Access Audit Site Report

Prepared By
WT Group

Choke Canyon State Park
700 TX-72
Three Rivers, TX 78071
Accessibility Evaluation
Inspection Date: 06/13/2022
Inspectors: Tanya Scheibe

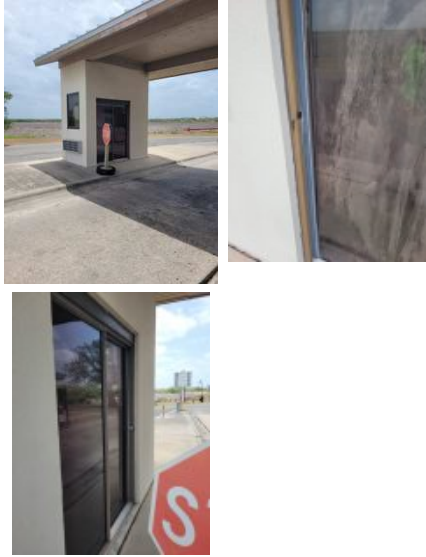
Finding Number	Area Description	Lat/Long	Finding	As Built	Recommendation	Citation	Photos	Figure
4	Headquarters (HQ) : HQ - Parking	[28.46601, -98.35448]	The cross slopes (narrow dimension) and/or running slopes (long dimension) of the access aisle exceeds 2%. The running slope and the cross slope in an accessible parking stall and the access aisle must not exceed 2%.	Calliham HQ - enter side, access aisle 7.7% slope, 5.3%; exit side, stall - 4.9%, access aisle - 6.1%	Repair or correct slope of parking space and access aisle to max 2.08% in any direction.	2015 ABAAS Section: 502.4 2012 TAS Section: 502.4 2010 ADAS Section: 502.4

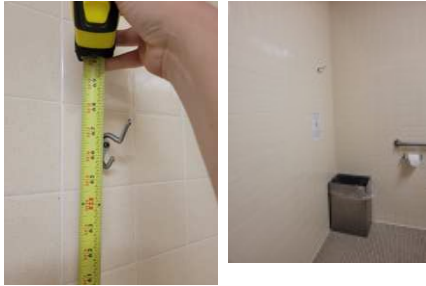
7	Headquarters (HQ) : Calliham HQ - Public Spaces	[28.4658131, -98.3541863]	The floor mat or carpet pile height is too high. Carpet or carpet tile shall be securely attached and shall have a firm cushion, pad, or backing or no cushion or pad. Carpet or carpet tile shall have a level loop, textured loop, level cut pile, or level cut/uncut pile texture. Pile height shall be 1/2 inch maximum. Exposed edges of carpet shall be fastened to floor surfaces and shall have trim on the entire length of the exposed edge.	2 of 2 rugs are not secure	Secure rug to prevent trip hazard.	2015 ABAAS Section: 302.2 2012 TAS Section: 302.2 2010 ADAS Section: 302.2

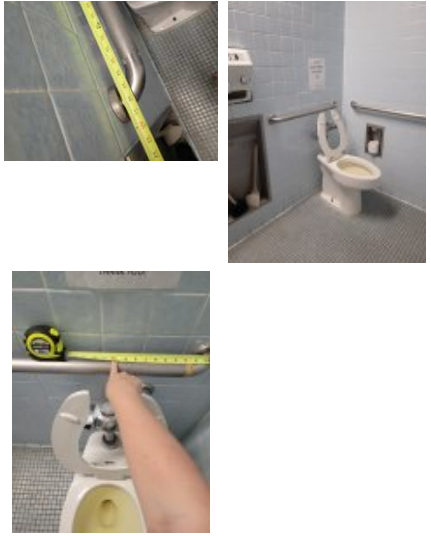
19	Headquarters (HQ) : Calliham HQ - Women's Restroom	[28.46601, -98.35448]	The grab bar height and/or spacing fails. Grab bars must be mounted between 33" and 36" to the top of the gripping surface. There must be 1.5" of clearance between the grab bar and the wall. There must be a minimum of 1.5" of clearance below and minimum 12" above the grab bar to any dispenser or other obstruction.	both 37" AFF	Remount grab bars in accessible stall to 33" to 36" above the finished floor (AFF).	2015 ABAAS Section: 609.3, 609.4 2012 TAS Section: 609.4, 609.3 2010 ADAS Section: 609.3, 609.4

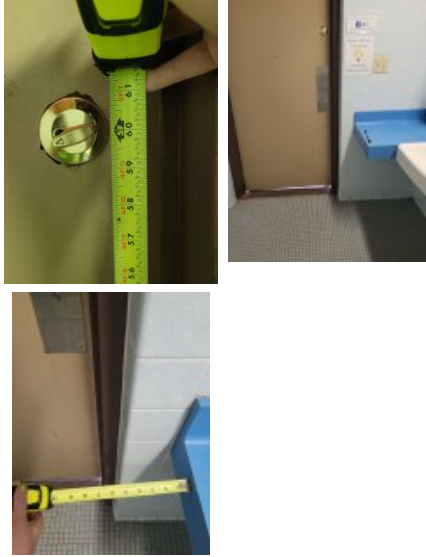
21	Headquarters (HQ) : Calliham HQ - Women's Restroom	[28.46601, -98.35448]	An item or items project more than 4 inches into the circulation path. Wall-mounted objects that have leading edges between 27 inches and 80 inches from the floor must not project more than 4 inches into the circulation path. Protruding objects that extend to the floor or within 27 inches of the floor are cane detectable and are therefore not hazardous. Where it is necessary or desirable to have objects protrude from the wall, a manner of cane detection must be provided.	hand dryer projects 5"	Relocate protruding objects or place cane detectable warning or bollard at foot of item.	2015 ABAAS Section: 307.2 2012 TAS Section: 307.2 2010 ADAS Section: 307.2		
22	Headquarters (HQ) : Calliham HQ - Women's Restroom	[28.46601, -98.35448]	The accessible route contains running slopes greater than 5 percent and cross slopes greater than 2 percent across the width of the walk and has not been constructed as a ramp (i.e. handrails, wheel guides, etc.). When the slope in the direction of travel of any walk exceeds 1 unit vertical in 20 units horizontal (5-percent slope), it must be constructed as ramp. Surface cross slopes must not exceed one unit vertical in 48 units. Horizontal (2-percent slope).	2.7% by drain	Correct or repair slope to max 5% running and 2.08% cross.	2015 ABAAS Section: 403.3 2012 TAS Section: 403.3 2010 ADAS Section: 403.3

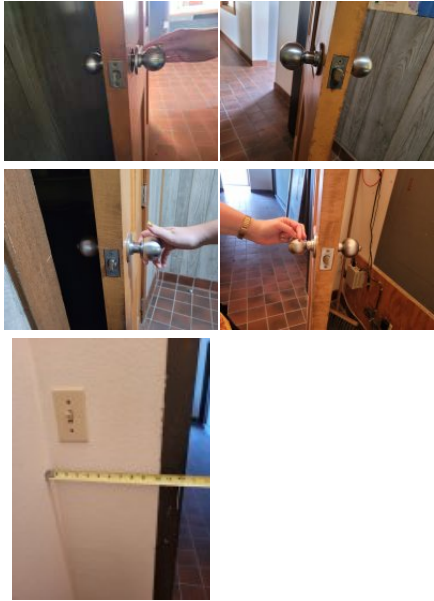
24	Headquarters (HQ) : Calliham HQ - Men's Restroom	[28.46601, -98.35448]	The restroom sign does not comply with one or more applicable requirements for the location, height, and properties of the sign.	sign on door, lacks Braille, lacks International Symbol of Accessibility, lacks raised characters	Replace sign with one of contrasting colors that includes Braille, raised characters, and the symbol of accessibility and mount on the wall, latch side of the door, 48" to the baseline of the lowest character and 60" to the baseline of the highest character.	2015 ABAAS Section: F216.2, 703.1, 703.2, 703.5, 703.6 2012 TAS Section: 216.2, 703.1, 703.2, 703.5, 703.6 2010 ADAS Section: 216.2, 703.1, 703.2, 703.5, 703.6

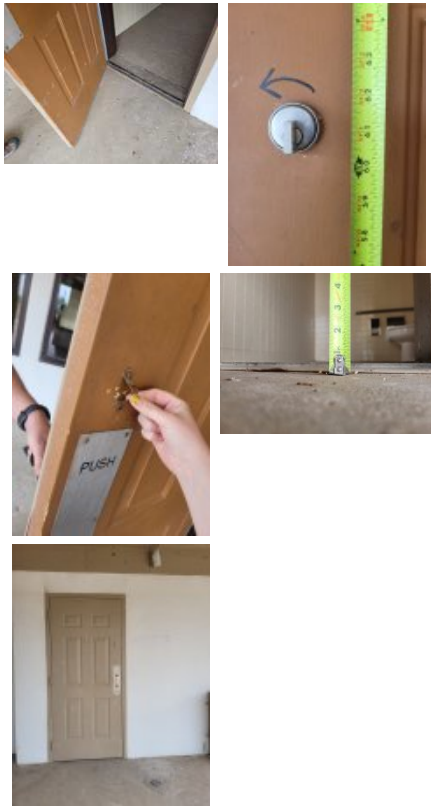
31	Headquarters (HQ) : Calliham HQ - Men's Restroom	[28.46601, -98.35448]	An item or items project more than 4 inches into the circulation path. Wall-mounted objects that have leading edges between 27 inches and 80 inches from the floor must not project more than 4 inches into the circulation path. Protruding objects that extend to the floor or within 27 inches of the floor are cane detectable and are therefore not hazardous. Where it is necessary or desirable to have objects protrude from the wall, a manner of cane detection must be provided.	dryer projects 5"	Relocate protruding objects or place cane detectable warning or bollard at foot of item.	2015 ABAAS Section: 307.2 2012 TAS Section: 307.2 2010 ADAS Section: 307.2

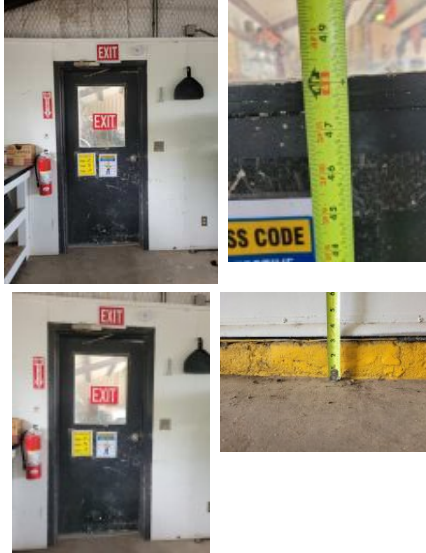
Finding Number	Area Description	Lat/Long	Finding	As Built	Recommendation	Citation	Photos	Figure
34	Headquarters (HQ) : South Shore HQ - Employee Spaces	[28.4673186 , -98.246496 9]	Employee Work Areas. Common use circulation paths within employee work areas shall comply with 402. EXCEPTIONS: 1. Common use circulation paths located within employee work areas that are less than 1000 square feet (93 m2) and defined by permanently installed partitions, counters, casework, or furnishings shall not be required to comply with 402. 2. Common use circulation paths located within employee work areas that are an integral component of work area equipment shall not be required to comply with 402. 3. Common use circulation paths located within exterior employee work areas that are fully exposed to the weather shall not be required to comply with 402.	25.5" width to back offices from entry	Make corrections for compliant circulation path.	2015 ABAAS Section: F206.2.8, F206.2.8.1, F206.2.8.2 2012 TAS Section: 206.2.8, 206.2.8 Exception 1, 206.2.8 Exception 2, 206.2.8 Exception 3, 206.2.8 Advisory 1, 206.2.8 Advisory 2 2010 ADAS Section: 206.2.8, 206.2.8 Exception 1, 206.2.8 Exception 2, 206.2.8 Exception 3

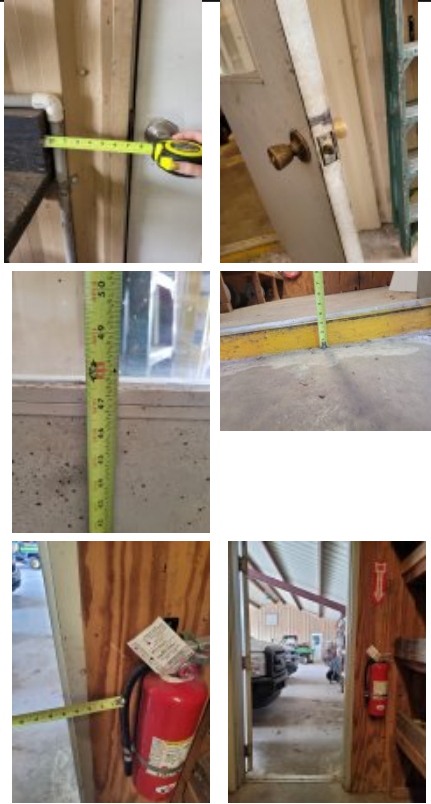
Finding Number	Area Description	Lat/Long	Finding	As Built	Recommendation	Citation	Photos	Figure
35	Headquarters (HQ) : South Shore HQ - Employee Restroom	[28.4673446 , -98.246494 3]	Knee clearance at 27 inches off the floor is not 8 inches minimum deep. The knee clearance, measured from the bottom of the apron or the outside bottom edge of the lavatory, must be 27 inches at a point located 8 inches back from the front edge and continuing to 11 inches minimum in depth at 9 inches above the floor. The top of the lavatory rim may be no higher than 34 inches.	trash in clear floor space	Remove trash bin to provide 8" deep knee clearance.	2015 ABAAS Section: 306.3.1, 306.3.2, 306.3.3, 306.3.4 , 306.3.5 2012 TAS Section: 306.3.2, 306.3.3, 306.3.4, 306.3.5, 306.3.1 2010 ADAS Section: 306.3.3, 306.3.2, 306.3.4, 306.3.5, 306.3.1		
36	Headquarters (HQ) : South Shore HQ - Employee Restroom	[28.4673116 , -98.246440 6]	The water and drain pipes under the lavatory are not adequately insulated. Water supply and drain pipes under lavatories and sinks shall be insulated or otherwise configured to protect against contact. There shall be no sharp or abrasive surfaces under lavatories and sinks.	pipes not insulated	Insulate exposed pipes under one sink.	2015 ABAAS Section: 606.5 2012 TAS Section: 606.5 2010 ADAS Section: 606.5

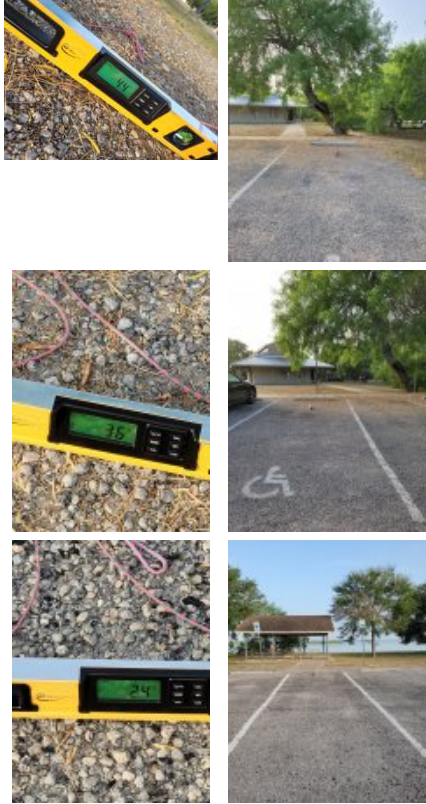
90	Calliham Unit (CU): CU - Parking	[28.4899226 , -98.3394288]	The access aisle is not a minimum 5 feet wide. A car accessible parking stall's access aisle must be a minimum of 5 feet wide measured from centerline to centerline. Where the access aisle is not adjacent to another parking space or access aisle, measurements shall be permitted to include the full width of the line defining the access aisle.	group pavilion at end of electric sites - 4'9" width	Repaint access aisles to be 5' each.	2015 ABAAS Section: 502.3.1 2012 TAS Section: 502.3.1 2010 ADAS Section: 502.3.1		
91	Calliham Unit (CU): CU - Parking	[28.4899049 , -98.3394435]	There are no van accessible parking stalls. 1 in every 6, minimum of one, required accessible stalls must be a van accessible stall. There are a total of 5 parking stalls in the parking lot that could be reasonably associated with this facility. There should be a minimum of 1 accessible stalls with a minimum of 1 being designed as van accessible.	group pavilion at end of electric sites - no van stall	Add van parking sign to one accessible stall and repaint stall and access aisle to 11' and 5' or 8' and 8'.	2015 ABAAS Section: F208.2, F208.2.4 2012 TAS Section: 208.2, 208.2.4 2010 ADAS Section: 208.2, 208.2.4

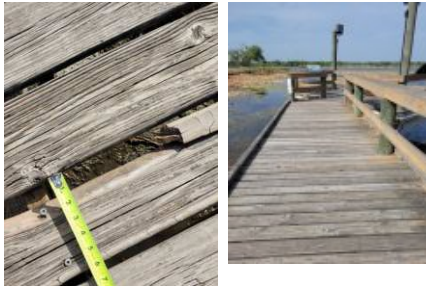
Finding Number	Area Description	Lat/Long	Finding	As Built	Recommendation	Citation	Photos	Figure
160	Calliham Unit (CU): CU - Park Elements	[28.4886924 , -98.344128 5]	There is no accessible route to the bird sanctuary. At least one accessible route shall connect accessible buildings, accessible facilities, accessible elements, and accessible spaces that are on the same site.	no route to bird sanctuary, within is not accessible surface	Create an accessible route with crushed stone or other outdoor material from parking or walkway to bird sanctuary	2015 ABAAS Section: F206.2.2 2012 TAS Section: 206.2.2 2010 ADAS Section: 206.2.2		
161	Calliham Unit (CU): CU - Campsites	[28.4726096 , -98.33711]	The surface of trails, passing spaces, and resting intervals shall be firm and stable	no route to primitive campsites by sites 200	Replace surface of trail with one that is firm and stable as a smart practice.	2015 ABAAS Section: 1017.2

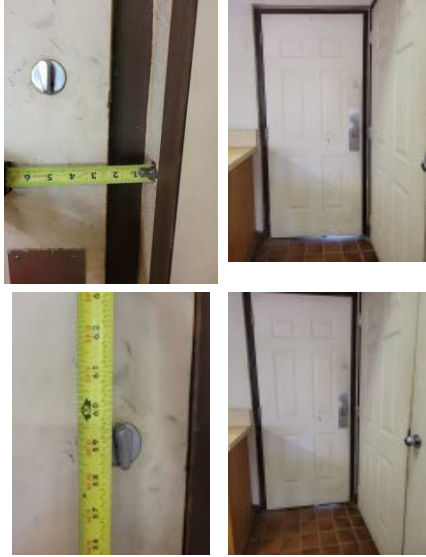
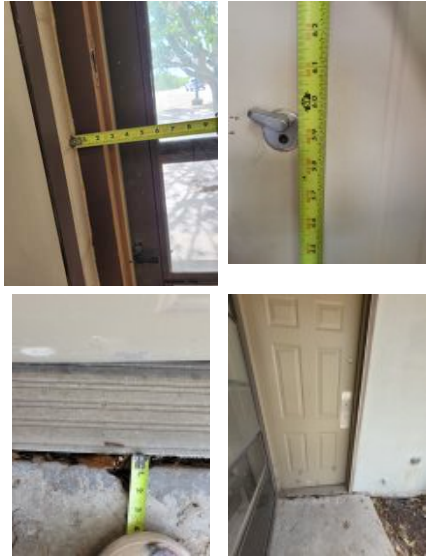
Finding Number	Area Description	Lat/Long	Finding	As Built	Recommendation	Citation	Photos	Figure
189	Calliham Unit (CU): CU - Fish Cleaning/ Shelters	[28.4899049 , -98.343914 8]	Objects project more than 4 inches into the circulation path. Wall-mounted objects that have leading edges between 27 inches and 80 inches from the floor must not project more than 4 inches into the circulation path. Protruding objects that extend to the floor or within 27 inches of the floor are cane detectable and are therefore not hazardous. Where it is necessary or desirable to have objects protrude from the wall, a manner of cane detection must be provided.	RV shelter by site 133 - fire extinguisher projects 7"	Relocate object to not protrude into the circulation path	2015 ABAAS Section: 307.2 2012 TAS Section: 307.2 2010 ADAS Section: 307.2		
190	Calliham Unit (CU): CU - Fish Cleaning/ Shelters	[28.4879223 , -98.347857 6]	Picnic tables shall provide at least one wheelchair space for each 24 linear feet (7320 mm) of usable table surface perimeter. Wheelchair spaces shall be 30 inches (760 mm) minimum by 48 inches (1220 mm) minimum. Wheelchair spaces shall be positioned for a forward approach to the table and provide knee and toe clearance complying with 306 under the table	screened shelter area across from restroom - 0 of 4 accessible	Replace picnic table with one of an accessible design as a smart practice	2015 ABAAS Section: 1011.4.2

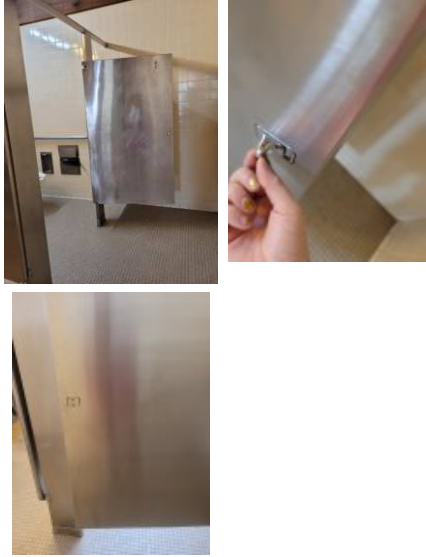
215	CU - Dining Hall: Dining Hall - Men's Restroom	[28.479678, -98.348455 8]	The restroom sign does not comply with one or more applicable requirements for the location, height, and properties of the sign.	sign on door, lacks International Symbol of Accessibility (ISA), Braille, raised lettering	Replace sign with one of contrasting colors that includes Braille, raised characters, and the symbol of accessibility and mount on the wall, latch side of the door, 48" to the baseline of the lowest character and 60" to the baseline of the highest character.	2015 ABAAS Section: F216.2, 703.1, 703.2, 703.5, 703.6 2012 TAS Section: 216.2, 703.1, 703.2, 703.5, 703.6 2010 ADAS Section: 216.2, 703.1, 703.2, 703.5, 703.6

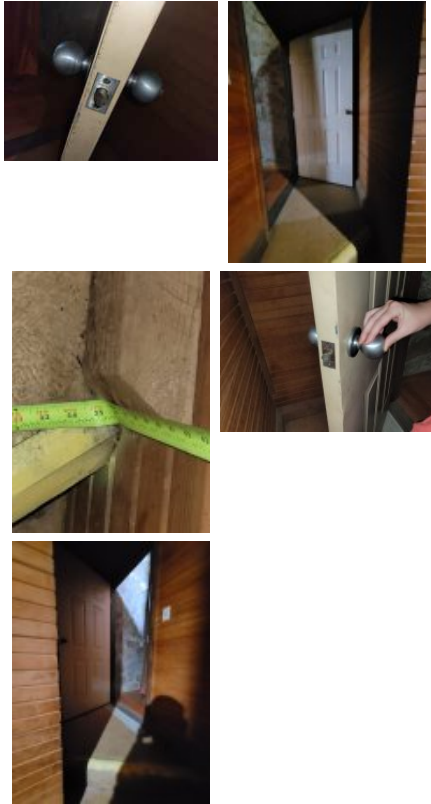
233	CU - Gymnasium: Gym - Public Spaces	[28.4797794 , -98.348729 3]	The top of the work surface is not within a compliant height range. The tops of tables and counters shall be 28 inches to 34 inches from the floor or ground.	0 of 10 tables provide knee clearance	Provide tables and work surfaces at 28" to 34" aff with required knee and toe clearances	2015 ABAAS Section: 902.3 2012 TAS Section: 902.3 2010 ADAS Section: 902.3

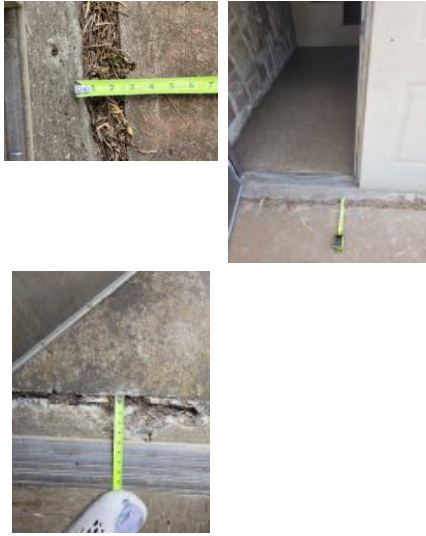
238	CU - Gymnasium: Gym - Public Spaces	[28.4797606 , -98.348729 3]	The handrails as well as the handrail extensions are not at the correct height. The tops of handrails and their extensions must be between 34 inches and 38 inches above the stair nosing or ground.	to stage- handrails both 27" AFF	Replace or remount handrails to 34" to 38" aff	2015 ABAAS Section: 505.4 2012 TAS Section: 505.4 2010 ADAS Section: 505.4		 <p>(a) stairs</p>

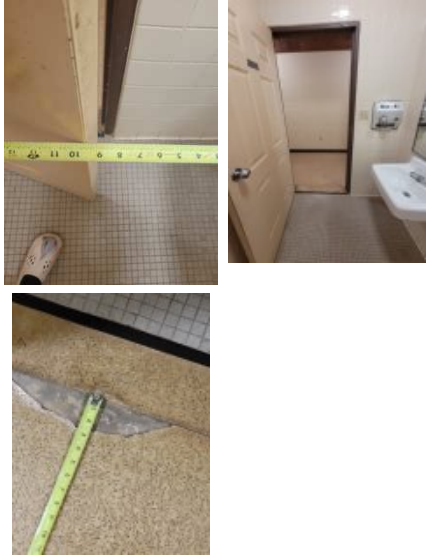
277	CU - Group Hall: Group Hall - Public Spaces	[28.4810148 , -98.351229 2]	The top rim of the sink is too high. All lavatories/sinks that are designated to be accessible shall be a minimum 17 inches in horizontal depth and mounted with the rim or counter edge no higher than 34 inches above the finished floor.	sink 36" AFF	Lower sinks to max 34" above the finished floor (AFF) to front of rim.	2015 ABAAS Section: 606.3 2012 TAS Section: 606.3 2010 ADAS Section: 606.3

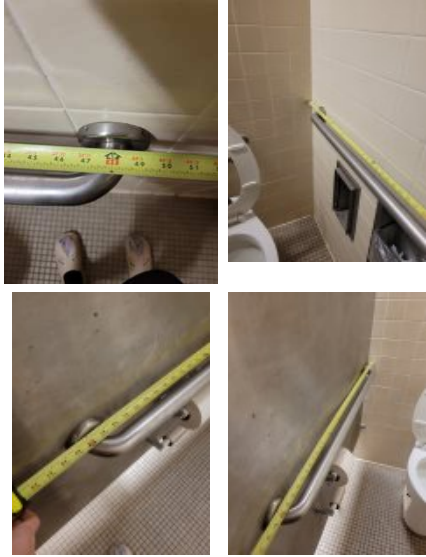
283	CU - Group Hall: Group Hall - Public Spaces	[28.4809983 , -98.351247 9]	Exterior doors exceed 8.5 lbs of force to open; fire doors shall have a minimum opening force allowable by the appropriate administrative authority	patio door - 18lbf	Inspect, adjust, and maintain 8.5 lbf to open exterior doors as a smart practice	2010 ADAS Section: 404.2.9		
284	CU - Group Hall: Group Hall - Public Spaces	[28.4810054 , -98.351269 4]	Minimum maneuvering clearances at doors and gates shall comply with 404.2.4. Maneuvering clearances shall extend the full width of the doorway and the required latch side or hinge side clearance. Maneuvering clearances shall have a max slope of 2.08%. The threshold has a gap greater than 1/2 inch wide.	back hallway exit - lacks clearance on pull, 1" gap	For all doors along the public circulation route, provide required maneuvering clearance on push and pull side of doors. For all doors along the public circulation route, fill gaps at door entries to max .5".	2010 ADAS Section: 404.2.3, 404.2.7, 404.2.4, 404.2.11, 404.2.11 Exception

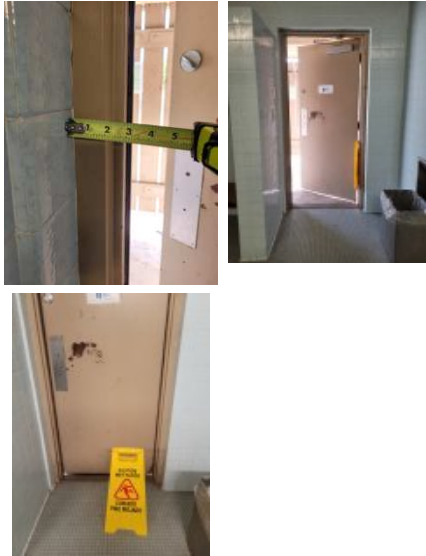
361	CU - Restrooms: CU, By Group Hall - Men's Restroom	[28.4804584 , -98.352041 9]	The restroom sign does not comply with one or more applicable requirements for the location, height, and properties of the sign.	sign lacks Braille, raised characters, and International Symbol of Accessibility	Replace sign with one of contrasting colors that includes Braille, raised characters, and the symbol of accessibility and mount on the wall, latch side of the door, 48" to the baseline of the lowest character and 60" to the baseline of the highest character.	2015 ABAAS Section: F216.2, 703.1, 703.2, 703.5, 703.6 2012 TAS Section: 216.2, 703.1, 703.2, 703.5, 703.6 2010 ADAS Section: 216.2, 703.1, 703.2, 703.5, 703.6

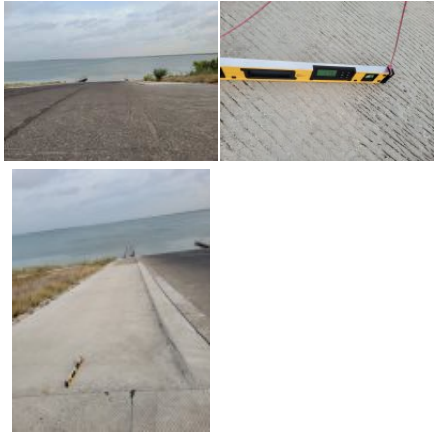
487	South Shore (SS), Day Use Unit: SS - Women's Restroom	[28.4723998 , -98.251665 6]	There are not enough accessible toilet compartments. The room contains toilet compartments. A minimum of 1 must be wheelchair accessible .	3 standard, 1 ambulatory stall	Create a wheelchair accessible stall with grab bars and fixtures mounted in correct locations and at correct heights.	2015 ABAAS Section: F213.3.1 2012 TAS Section: 213.3.1 2010 ADAS Section: 213.3.1
